June 20, 2018

Our Project No.: AA16-053B

**Re: 19-59 Lowes Road, City of Guelph  
Scoped EIS Addendum Report**

Title:  
**EXISTING CONDITIONS  
 & DRAINAGE CATCHMENT**

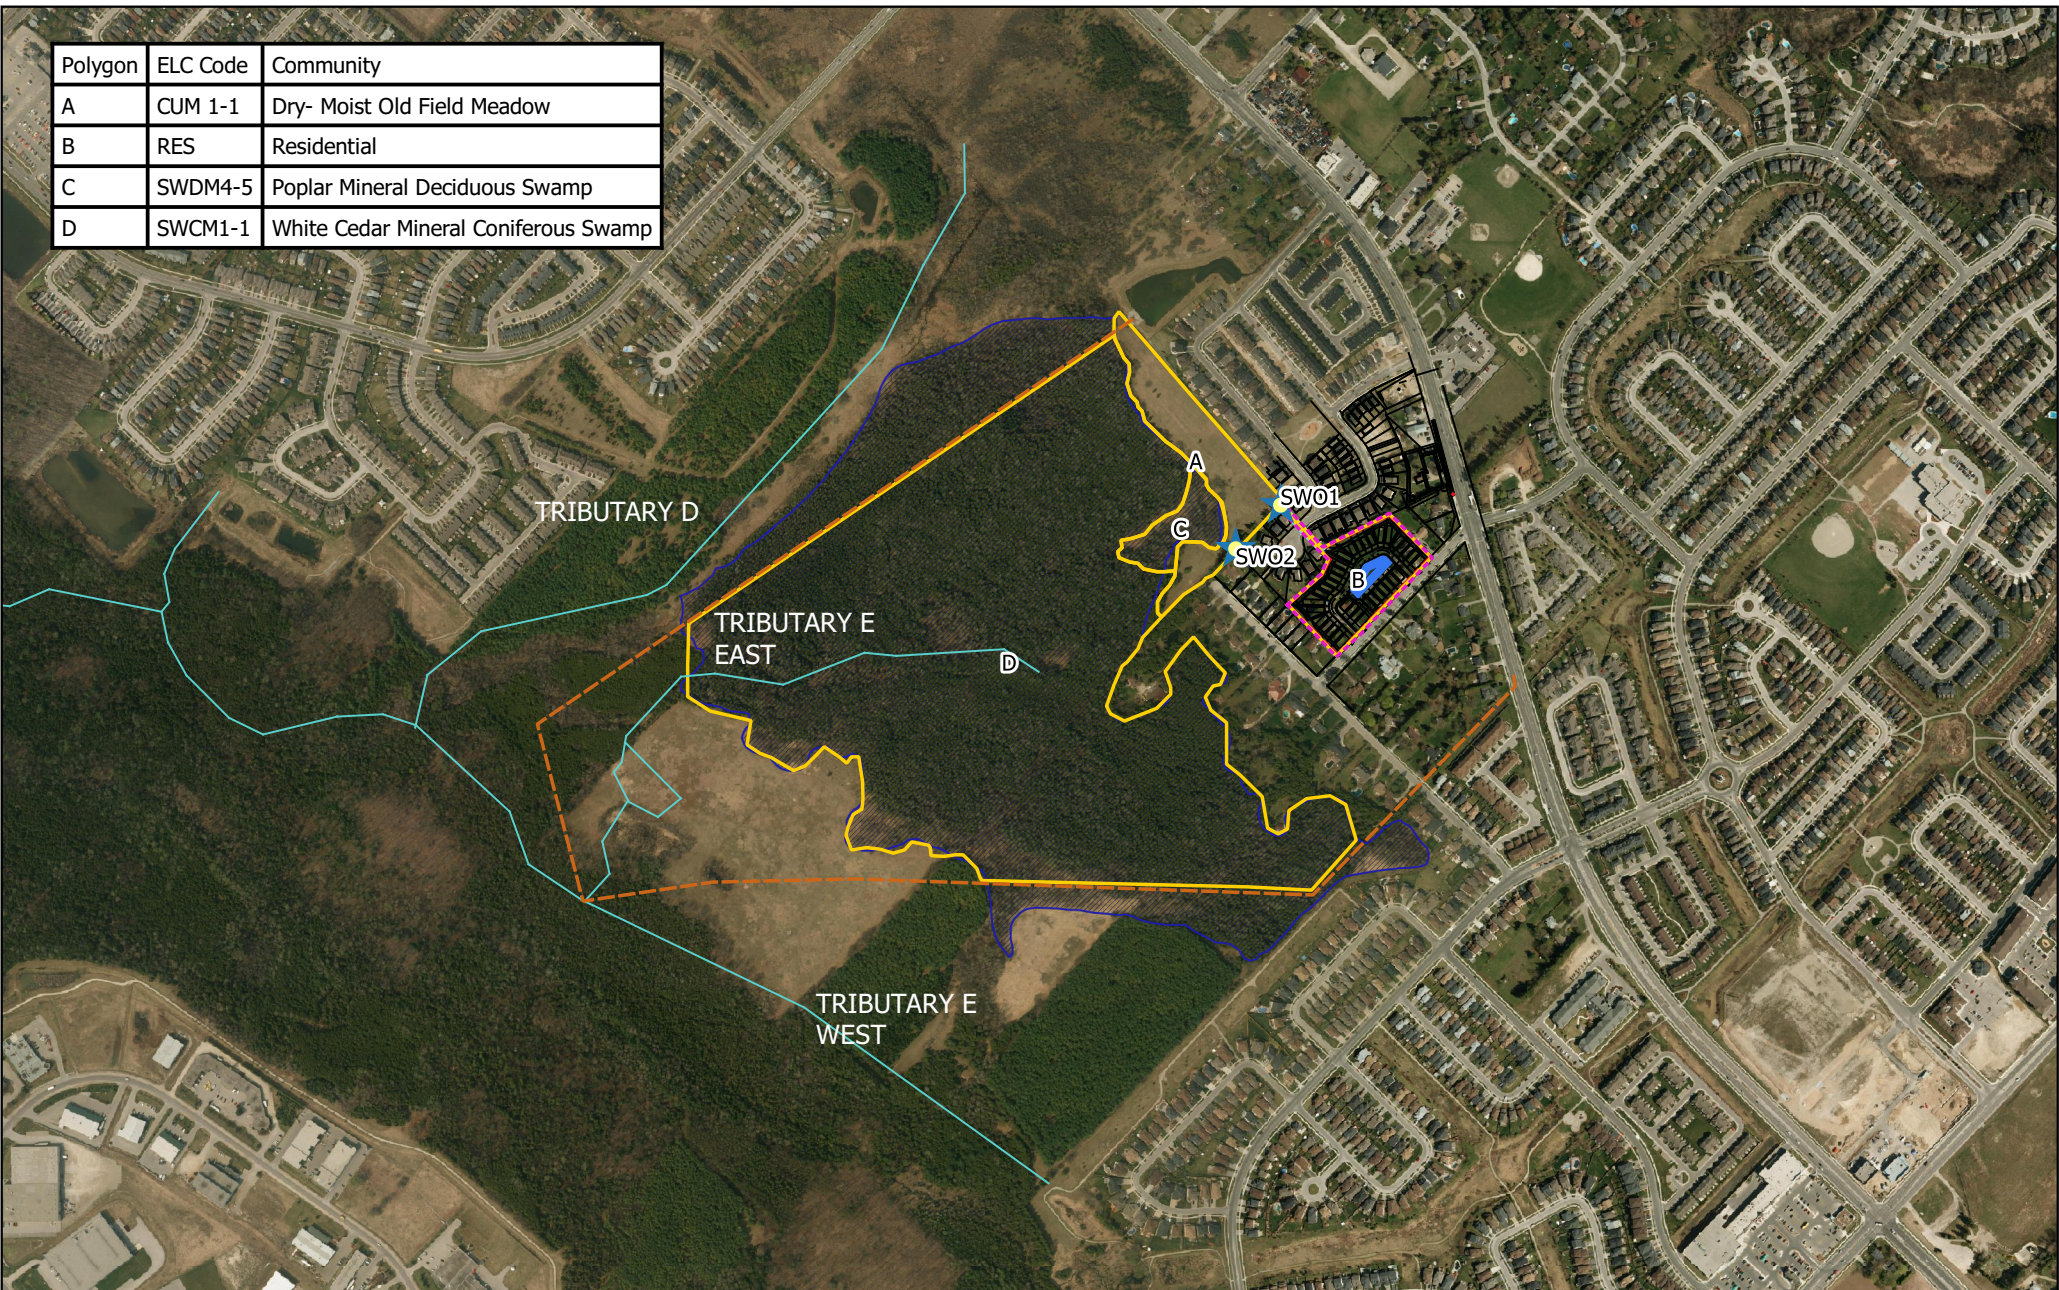
*“The EIS and supporting documents were specifically to include a natural feature water balance per comment 10 above. This is required to demonstrate the potential impacts as a result of the proposed development and how they are being mitigated.”*

*“The EIS notes an annual increase in runoff to the wetland of 3,384m<sup>3</sup> per year and that this represents the equivalent of 0.16mm event over the direct surface runoff of the entire (Hanlon?) watershed. Given that we are dealing with a sub catchment for an unnamed tributary that connects to Tributary E of the Hanlon Creek subwatershed- this would appear to be a substantial increase. The submitted EIS addendum adds rates (mm/yr) based on supplement information regarding infiltration and water balance information for the site, yet neither document provides an analysis on how this demonstrates the protection or enhancement of the quality and quantity of water of the hydrological functions of the wetland. The peer review comments provided by Cole Engineering also identified concerns and provided recommendations regarding these concerns which should also be incorporated and addressed.*”

Stantec completed a feature-based water balance for the 62.1 ha catchment area that drains to Tributary E, as delineated in the Preliminary Stormwater Management Report (Stantec, 2018). The results of the feature-based water balance indicate that based on the proposed development, and its infiltration strategy, the change in annual infiltration/recharge values for the catchment is 0 mm/year, however there will be an increase in surface runoff on an annual basis. Following development of the 1.7ha site, the increase in annual surface runoff within the 62.1ha catchment was calculated to be 187mm or a surplus of 5mm/year, ultimately representing a 3% increase. The highest surplus of runoff occurs in April with 854mm, while the lowest occurs in December with 270mm. The feature-based water balance and calculations, in their entirety, can be found in the Preliminary Stormwater Management Report (Stantec, 2018).

Based on the feature-based water balance completed by Stantec, the surplus in surface runoff to the wetland feature is calculated to be 5 mm/year, which represents a 3% increase over the 62.1ha catchment on an annual basis.

Additional site visits were conducted to investigate the wetland feature within the identified drainage catchment. The wetland feature within drainage catchment currently consists of two different vegetation communities, a White Cedar Mineral Coniferous Swamp, approximately 45.53 ha, and a Poplar Mineral Deciduous Swamp, approximately 1.19 ha. Through field observations, it was noted that the Poplar community, closest to the existing residential dwellings consists largely of grasses, sedges and herbaceous species throughout standing water, and that numerous standing snags of Balsam Poplar (*Populus balsamifera*) and Trembling Aspen (*Populus tremuloides*) are present, indicating a transition within the community. Through examining Google Earth imagery from 2006 to 2017, it was noted that the transition can be attributed to the significant influx of discharge from SW02 as the channel formed by the discharge from SW02 is evident beginning in 2013 and coincides with changes in the canopy. Although the canopy experiences slight changes, the approximate size and shape of the above noted community has not significantly altered, indicating that the Eastern White Cedar Swamp has not been influenced by the additional surface flows. The surface runoff triggering this transition has likely caused a shift in the vegetation present in the buffer community, resulting in the growth of highly tolerance species such as Reed Canary Grass (see Sections 2.3 & 2.4).

Figure 1. TRCA Risk Assessment Decision Tree

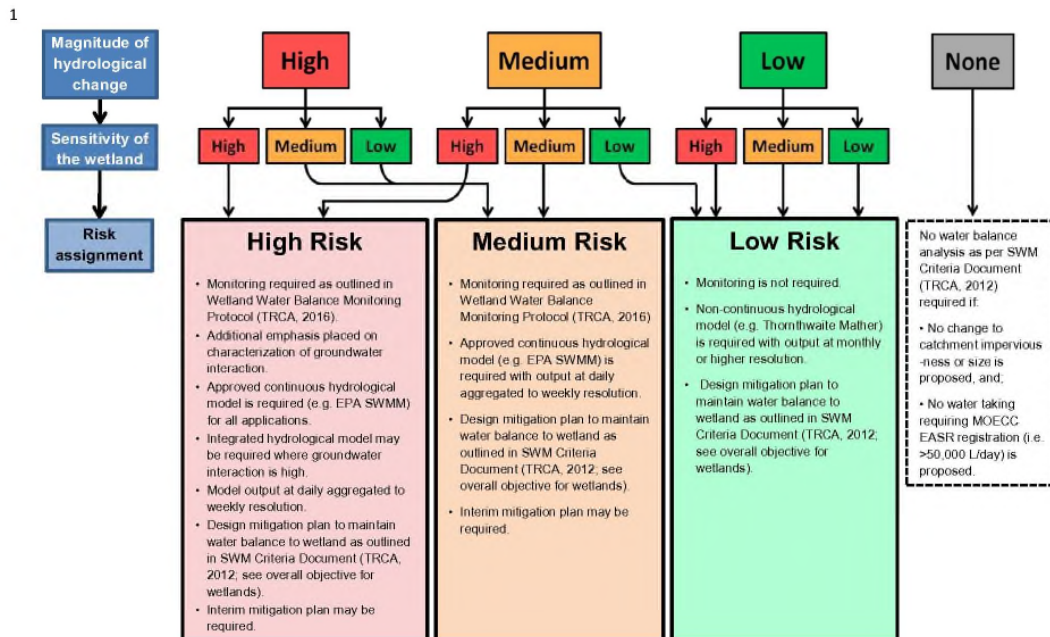
Based on the criteria evaluated in steps 2 and 3, the TRCA has developed a decision tree (Figure 1) to categorize the development proposal into one of three levels of risk; Low, Medium or High. Based on the categorization, the proposed development qualifies as being Low Risk to the existing wetland feature.
